Planning Board

Thursday, May 21, 2026: 6:00 PM

Planning Staff Report

Item: Chandler Pond Way Conceptual Development Plan (CDP)

Figure 9: Proposed Watershed and Unit Breakdown by Acreage.

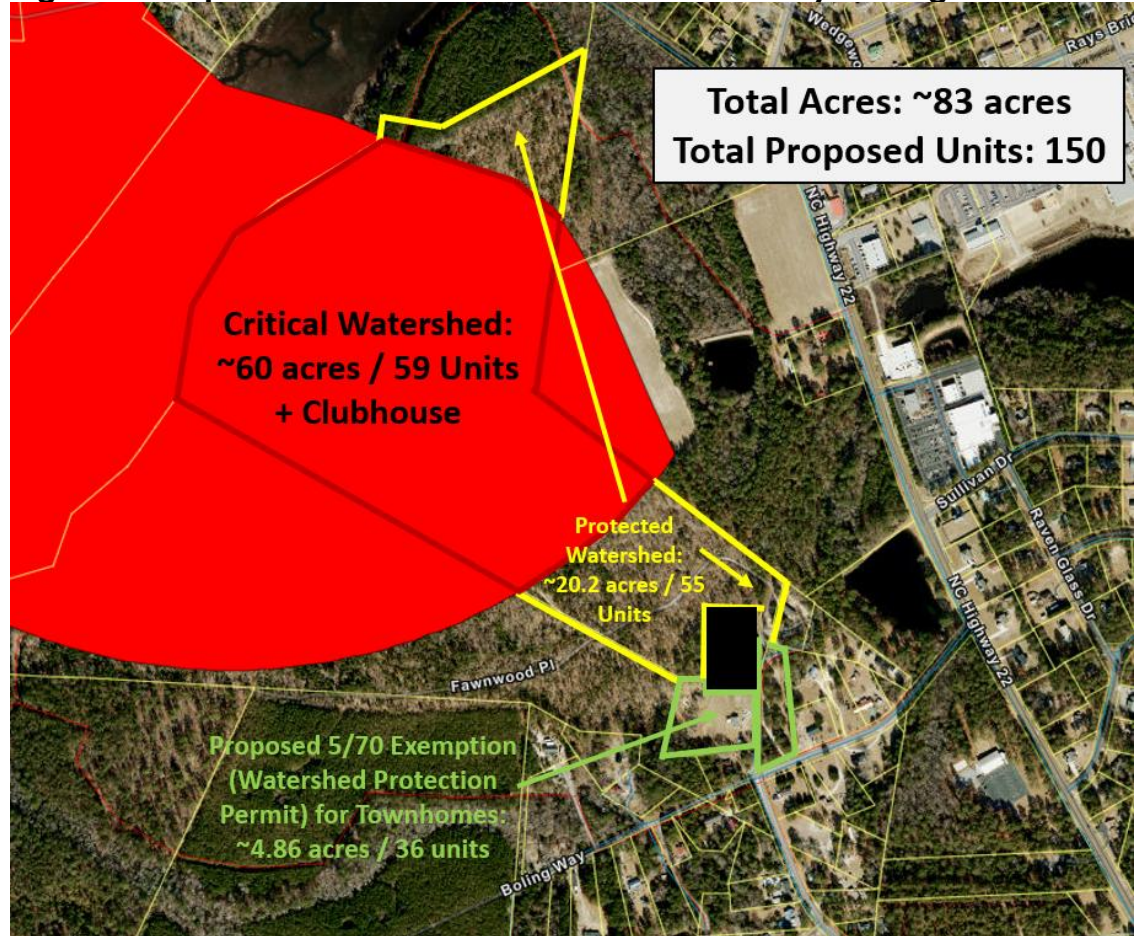
(UDO Exhibit 3-14). As mentioned above, staff support a 5/70 exemption allocation for the 36 townhomes on the proposed ~4.86-acre “Land Area C,” as shown in the concept plan, which would enable the increased density.

Next, applicant has provided the following impervious surface breakdown in CDP table 4.0. Though 1 dwelling unit per acre is the requirement to maintain in the critical area, staff note that total impervious surface percentage for the critical area is missing. This percentage would provide good context.

Figure 10: Opportunity for Increased Buffer Widths.

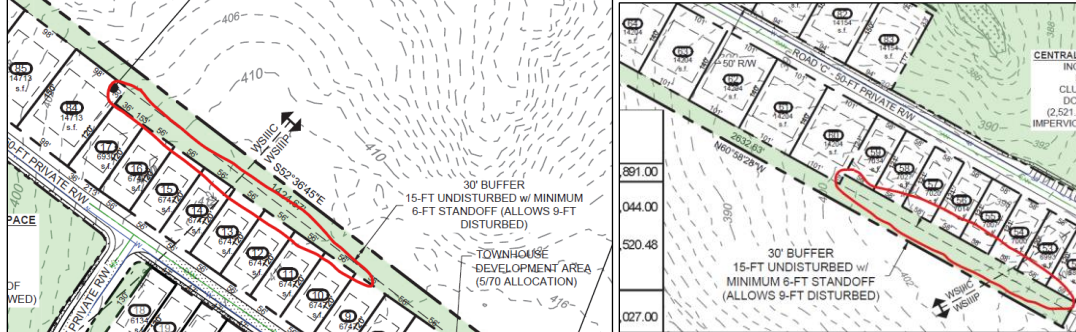
For example, a buffer is shown between the proposed Ravensbrook 5 and the approximately 42-acres of land owned by James Mabe to the east. This buffer could be 40-50 feet wide in multiple areas, and given the Mabe property is rural in character, a robust buffer should be provided (see figure 10 below). With a 30-foot buffer, the buffer standards also only commit to 21-feet being undisturbed.

- Change the undulating buffer width from 10-30’ to 10-50’ (where applicable – see figure 10).
- Regarding the “planted or undisturbed buffer,” staff recommend using the following language to reduce ambiguity:
“For buffer areas labeled “planted or undisturbed,” existing trees and shrubs shall be incorporated and protected to the maximum extent feasible. No new plantings shall

3. **Buffering.** Bolster the buffer standards to include the following:
 - a. Change the undulating buffer width from 10-30’ to 10-50’ (where applicable – see figure 10).

Figure 11: Fawnwood Place Access and Adjacent Properties.

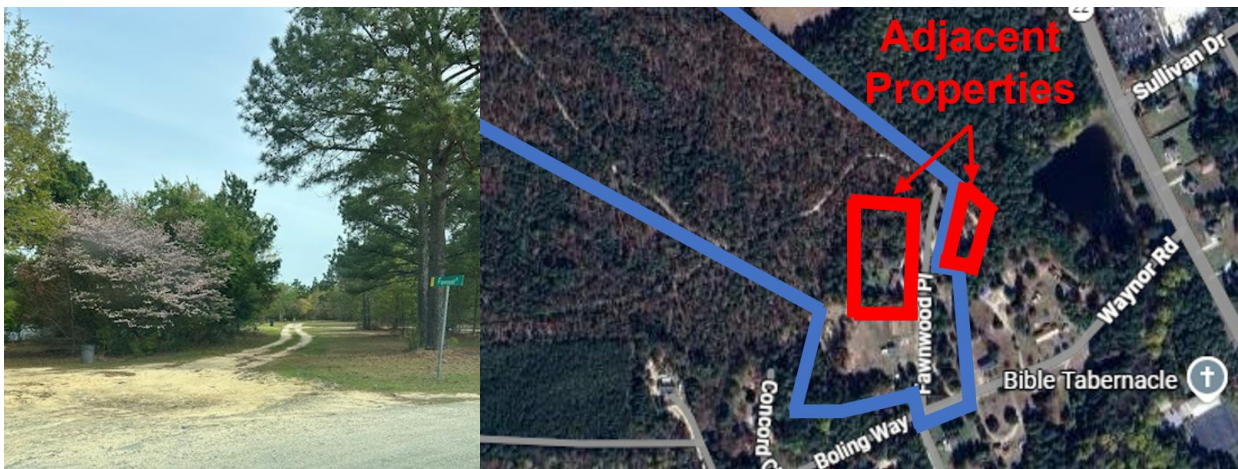
Construction Impacts on Neighboring Lands. Only one point of access is presently available for construction traffic during the proposed 10 years of phased development—via Fawnwood Place. This private drive is the only means of access for multiple neighbors, meaning that privacy, safe ingress and egress, and nuisance is an important factor to consider for a proposed decade-long period of development. For added context, three parcels owned by Alphas Cobb will be land-locked inside of the proposed Ravensbrook 5 development, and Fawnwood Place (a private road) will be the only means of access during and after construction. Next, the parcel owned by Everett Bland will also only have access via Fawnwood Place during and after construction. This parcel is also immediately next to the portion of roadway that the applicant has asked for a deviation in right-of-way width down to 40-feet. Lastly, the Ravensbrook 5 site is surrounded by parcels of natural and rural-area character. See figure 11 below for ground photos.

The applicant has included mitigation measures for construction traffic, noise, and safety in CDP §7.0. Those include 7am – 7pm hours of operation, generally keeping staging areas at least 100 foot set back, and generally keeping construction traffic away from the

Figure 5: Caropines Phase I Preserved Open Space Areas.

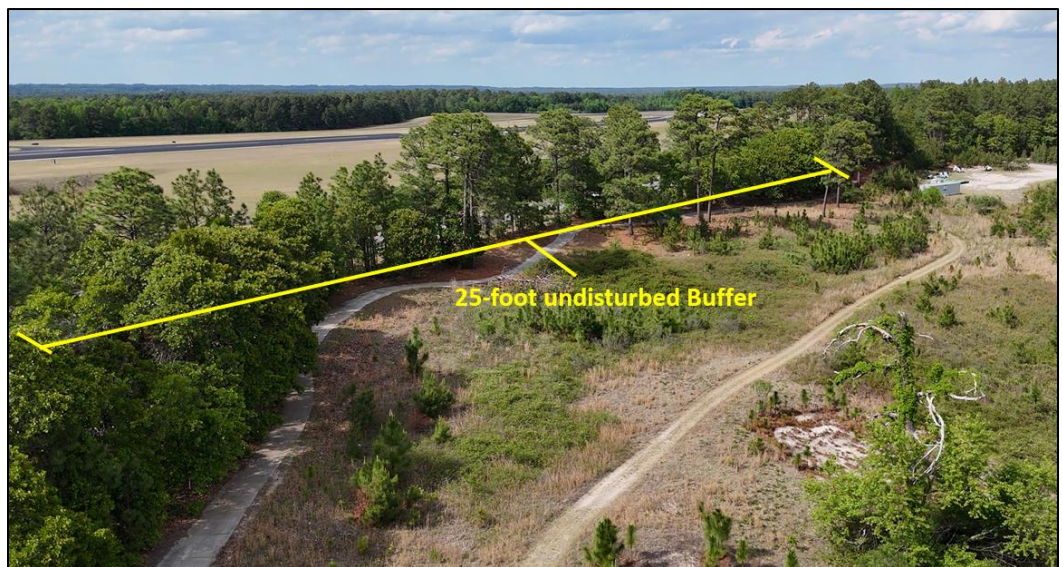
To ensure these proposed areas to be preserved are sufficiently protected, staff recommend including a condition of approval that states all tree protection fences must be installed prior to any site clearing, remain in place throughout construction, and maintain a minimum 6-foot separation from the applicable buffer, wetland delineation line, and/or trees to be preserved. With this condition of approval included, staff find the application will satisfy this criterion.
